MIL-STD-202F

TEST METHODS FOR ELECTRONIC AND ELECTRICAL COMPONENT PARTS

NOTICE OF
CHANGE

MIL-STD-202F
NOTICE 11
1 June 1992

FIGURE 101-1. Salt solution filter.FIGURE 101-2. Location of salt solution filler.

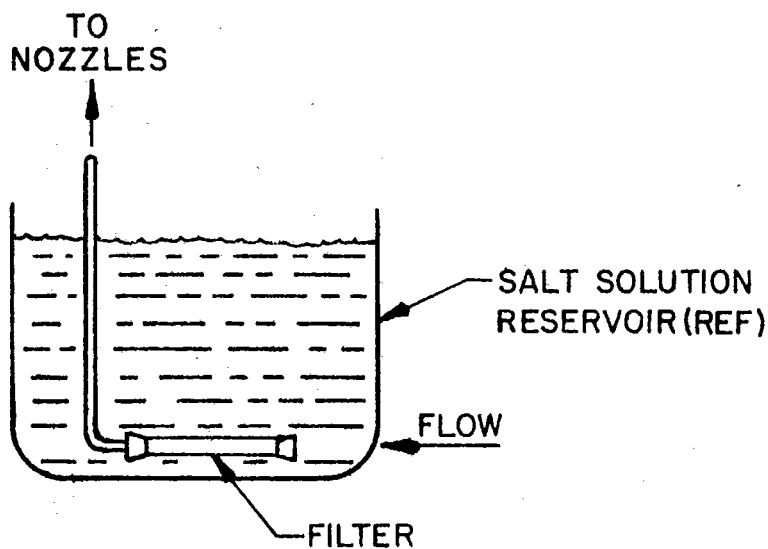
METHOD 101D, PAGE 3, FIGURE 101-2, TITLE: Delete "filler" and substitute "filter".
